DEVELOPMENT APPLICATION ASSESSMENT REPORT

Application Number:	DA2025/0037
----------------------------	-------------

Responsible Officer:	Thomas Burns
Land to be developed (Address):	Lot 13 DP 25368, 41 Ferguson Street FORESTVILLE NSW 2087
Proposed Development:	Demolition works and construction of a dual occupancy including swimming pools
Zoning:	Warringah LEP2011 - Land zoned R2 Low Density Residential
Development Permissible:	Yes, under State Environmental Planning Policy (Housing) 2021
Existing Use Rights:	No
Consent Authority:	Northern Beaches Council
Land and Environment Court Action:	No
Applicant:	Mark Makhoul

Figure 1 - diagram showing height exceedance on the site plan

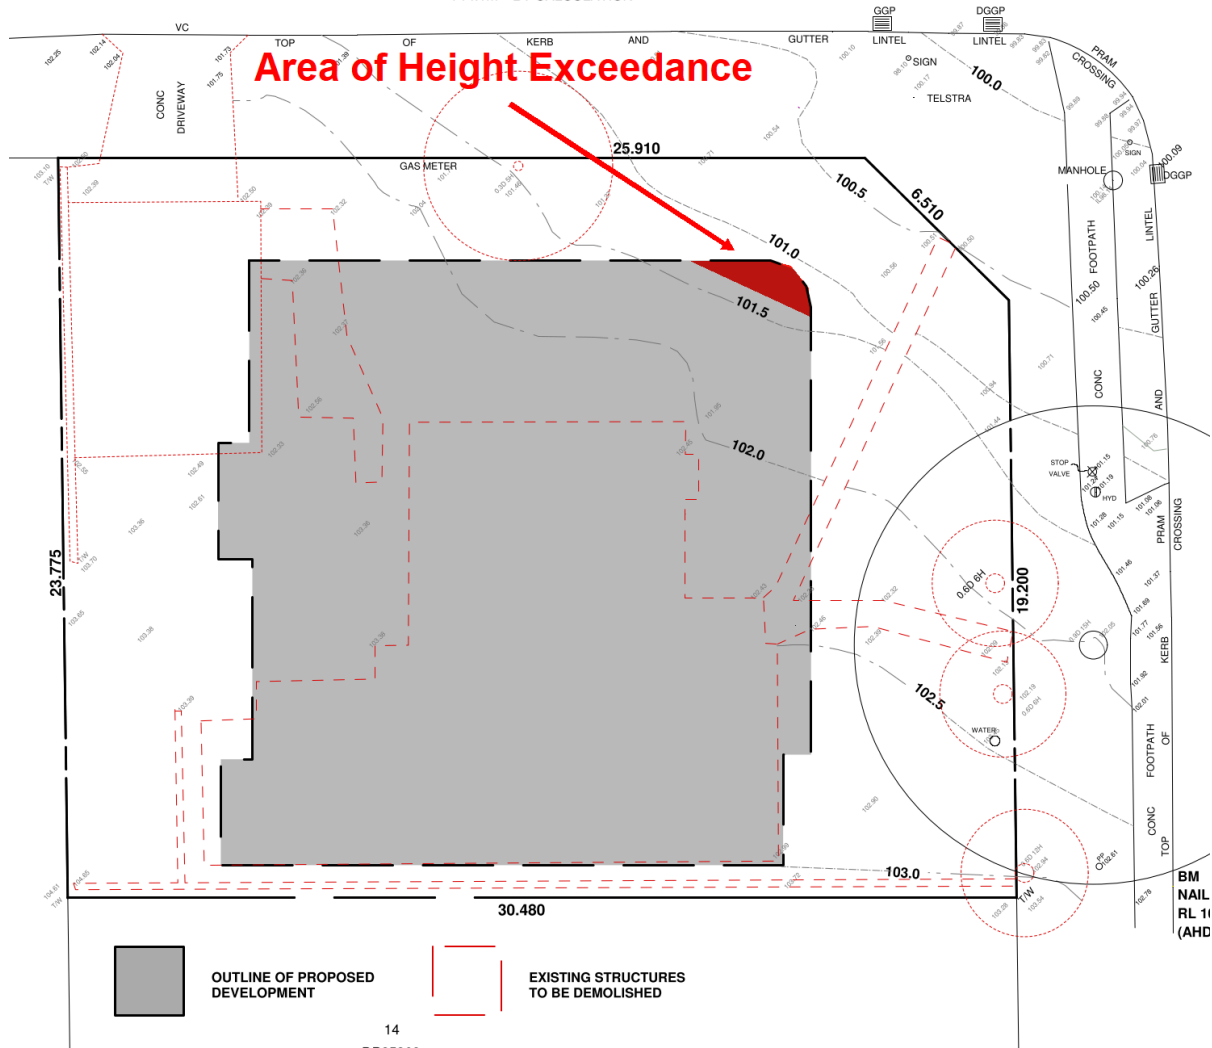
Area of Height Exceedance

The non-compliance is derived from the slope of the land and is confined to a corner of the building eave. This element of the building does not add any significant building size, height or bulk that would render the development incompatible with the height and scale of surrounding development.

Figure 5 - side building envelope non-compliance (shaded in green)

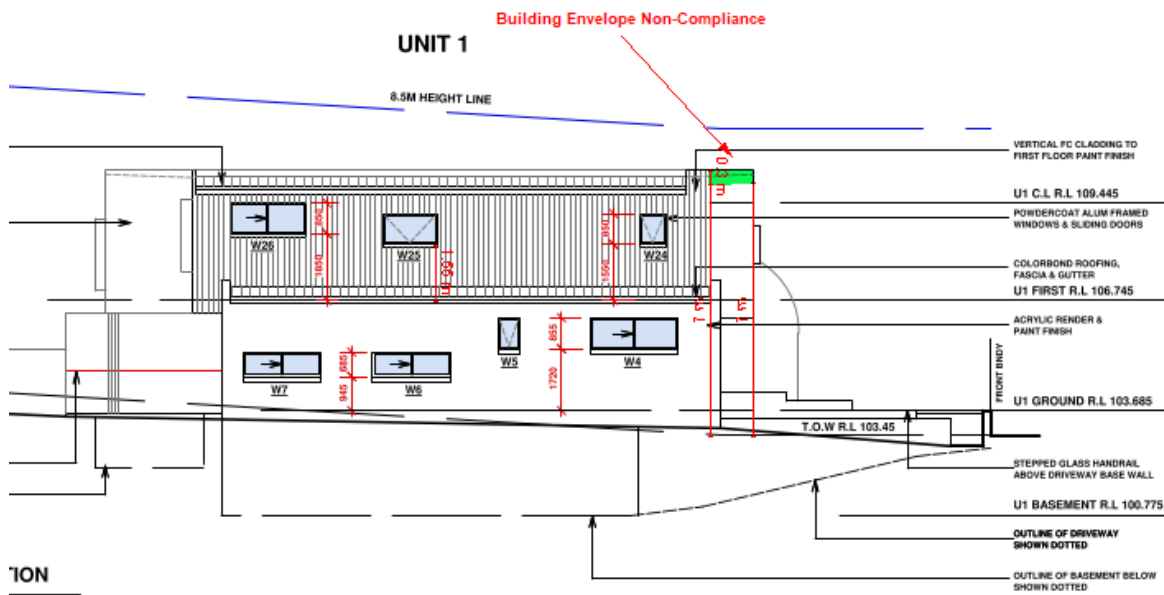
The development is largely compliant with this control; however, there is a small area of the building on the south-eastern elevation encroaches outside of the side building envelope requirement (see **Figures 5-6**).
